The core paths consultation in the Lomond and Trossachs National Park

The proposals for Ben Ledi and its environs

Key: purple = existing; green = addition; brown = removal; blue = re-alignment; black (added by me) referred to in text below

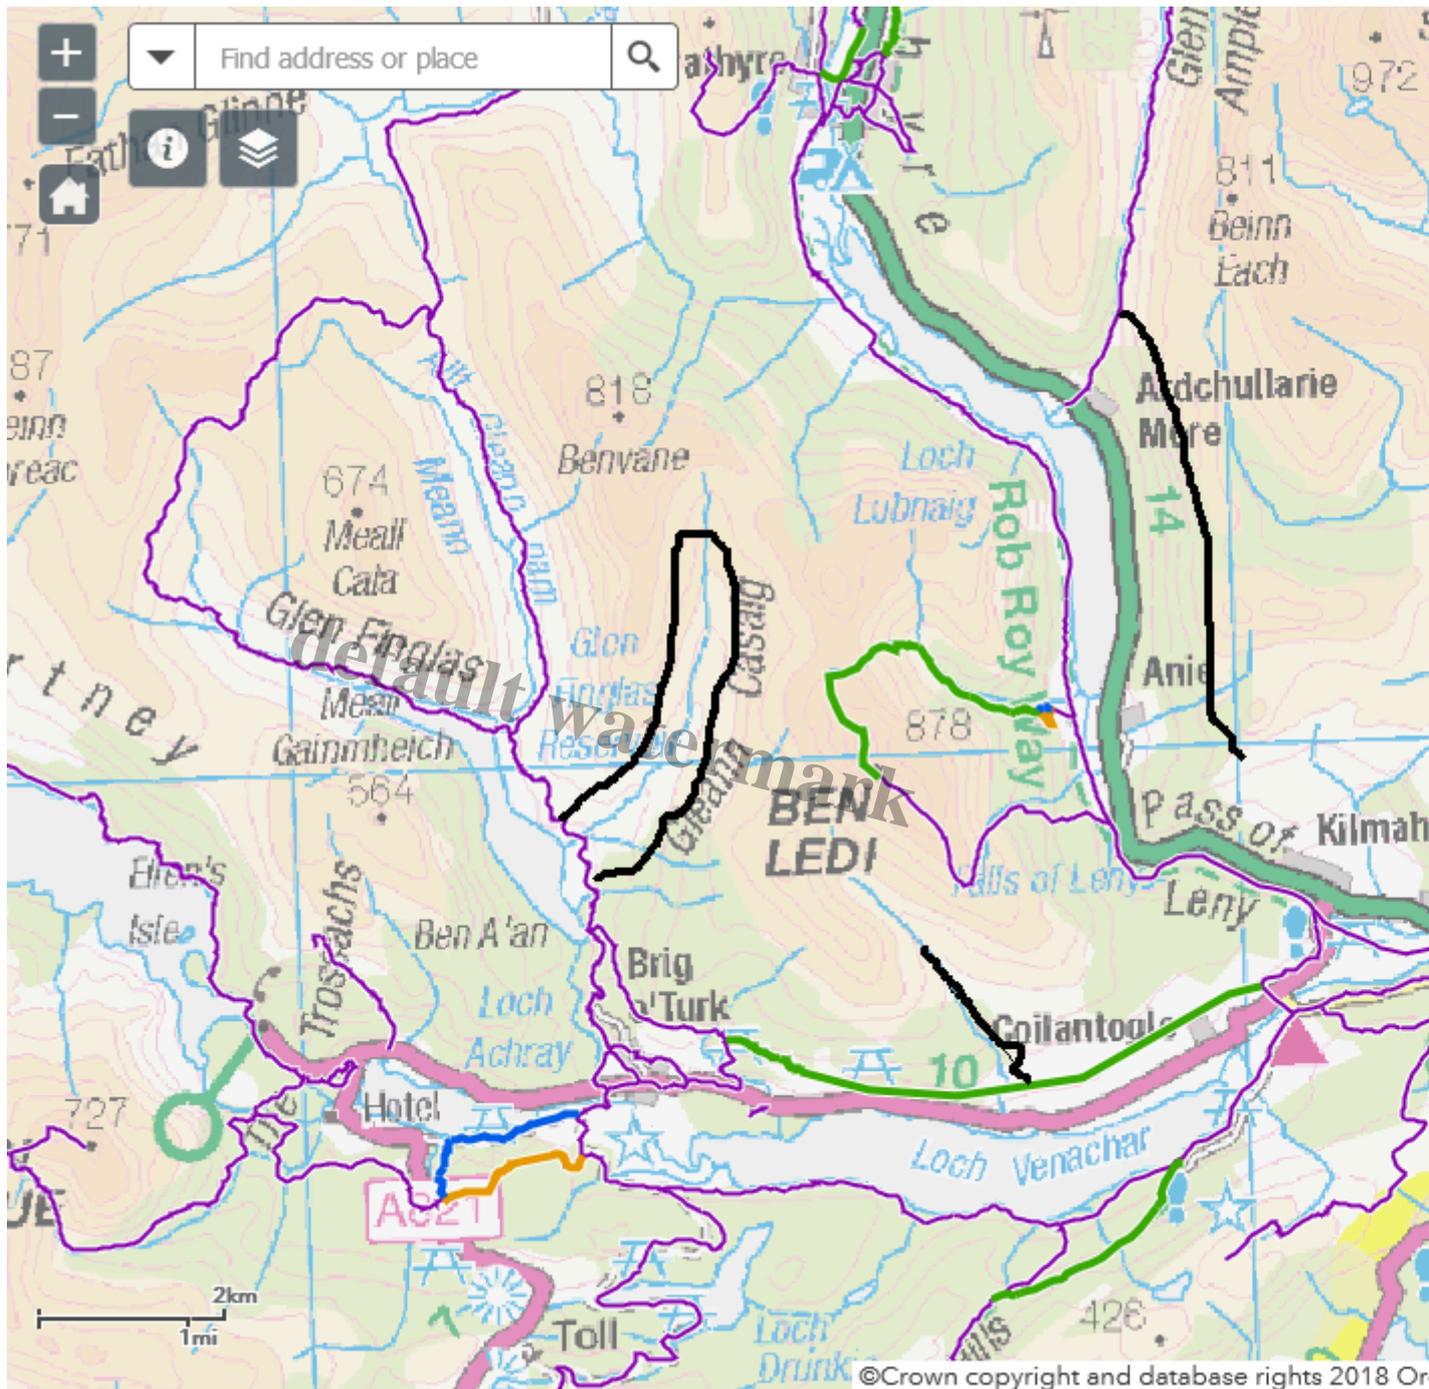
There are three main additions included in this section of the map, the path to the summit of Ben Ledi via Stank Glen, the Great Trossachs Path on the north side of Loch Venachar and a section of the Rob Roy Way on the south side of Loch Venachar. These are all welcome.

This path only scores 4 or more on FIVE of the criteria and therefore does NOT according to the Park's policy qualify for being added to the core path network. No doubt someone in the Park will claim there has been a typographical error somewhere to save face. However, I believe that its not the scoring that is the issue but the criteria used. These which don't allow for paths like the Stank Glen route up Ben Ledi to be added to the core path network.

Its worth noting here that one of the justifications for the horrible hydro track up Gleann Casaig, which I have marked as a black line even though I believe it should be removed, is that it would create a new circular walking route. If that was really true, why has it not been added to the core path network? There is still almost no join up between the LLTNPA as a Planning Authority and the LLTNPA as an Access Authority. The recreational experience in the National Park would be greatly improved if the worst hydro roads were converted into paths no more than 1.5m wide (i.e suitable for ATV use only) and linked into the core path network.

The re-alignment of the core path at Forest Drive (bottom left of map), raises further questions about the LLTNPA's criteria and scoring system. While the direct link to Brig O' Turk (blue line) makes sense, the former route (brown line) no longer meets the criteria. The change results from a re-aligning of the National Cycle Network and, simply because the brown path is no longer promoted as a national route, it now drops out of network (meeting only 5 rather than 6 of the ten criteria). Actually, it adds to people's choice, so why remove it? If the LLTNPA had adopted more recreational based criteria, it would not have to propose that routes like this were removed from the path network.

This failing could be addressed if the LLTNPA created additional recreational criteria to evaluate a path's importance. For example,

- Its popularity (and the extent to which regular path work/maintenance is required (being a core path does not create any requirement for the Access Authority to maintain it but could be used to prioritise paths which need investment)
- Encouraging more people to get out into the great outdoors (with all the physical and mental health benefits that provides)
- Providing alternative routes to spread/manage visitor pressure
- Breaking down the single criterion about "Providing enjoyment of the Park's special qualities" into a number of separate criteria such as "Enjoyment of landscape", "enjoyment of nature" and "enjoyment of the cultural heritage".
- A route has been endorsed in a Planning Application as adding to the recreational experience (e.g as has happened with many hydro tracks)
